UPC2 851-861 Burke Road, Hawthorn East

Application no.: PA16/00108 (File 40/409/00884)

STATUTORY PLANNING OFFICERS REPORT Urban Planning Special Committee

Appendix A - "Without Prejudice" Amended Plans for the 16 March 2017 VCAT Compulsory Conference

EAST ELEVATION - BURKE ROAD

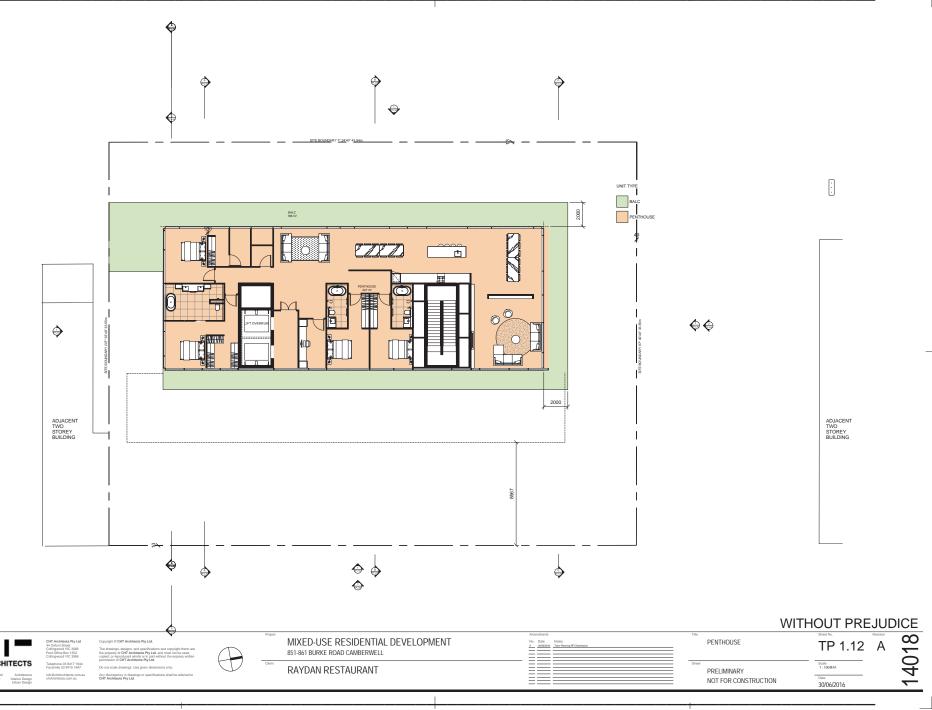
The height of the street wall facing Burke Road, for the middle section of the building adjacent to the former State Savings Bank front façade, would be reduced in height so that it matches the height of the retained former bank façade. (See Condition 1f)

NORTH ELEVATION - MAYSTON STREET PRELIMINARY NOT FOR CONSTRUCTION

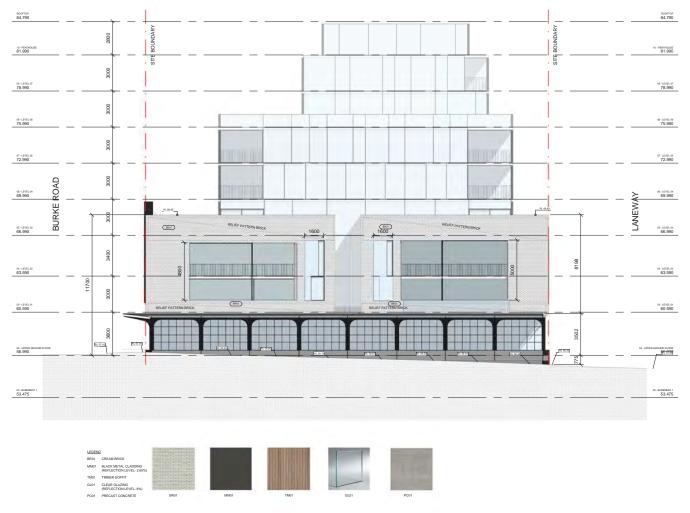
The height of the street wall facing Mayston Street is not proposed to be decreased. Facing Mayston Street, the 'without prejudice' amended plans show the building would have a maximum street wall height of 12.475m (compared to a maximum of 11.7m facing Burke Road).

It is acknowledged that the amended plans and recommended permit conditions do not directly address this ground of refusal. However, it is considered that the recommended reduction in the overall height of the building will assist in ameliorating the impact of the development on the character of Mayston Street. In addition, the requirements of Condition 1h to provide a pedestrian entrance to the restaurant from Mayston Street and Condition 1k to redesign the Mayston Street plinth will improve the building's interface with the street. Having regard to all of the other matters that are addressed by the amended plans and recommended permit conditions, it is the view of officers that the issue of the street wall height facing Mayston Street alone does not warrant maintaining a position of opposition to the development.

SOUTH ELEVATION PRELIMINARY NOT FOR CONSTRUCTION

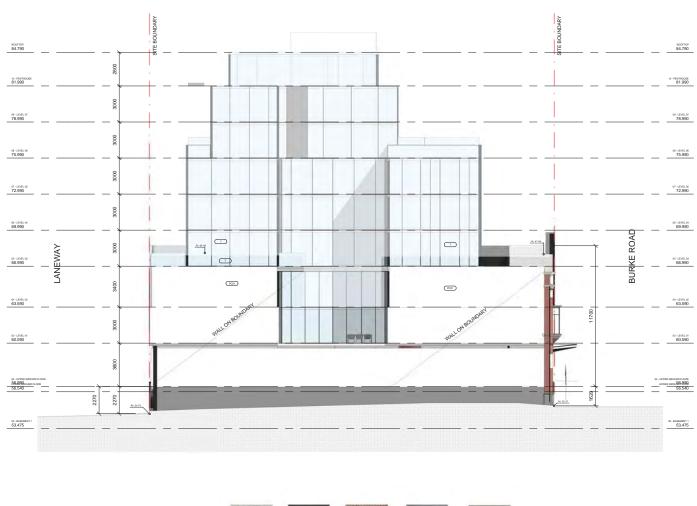
- The size of the southern light well has been increased in the amended plans (from 4.5m x 6.497m, to 4.5m x 9.0m). In addition, a further area setback area adjacent to the southern boundary of 3.0m x 11.7m is required to be provided for Levels 3, 4, 5 and 6 (See Condition 1c). The additional setback area provides improved outlook for the dwellings and increases the separation between the development and any future development that might occur at No. 849 Burke Road. The setback from the southern boundary for the floors above the street wall will also substantially increase articulation in the southern elevation.
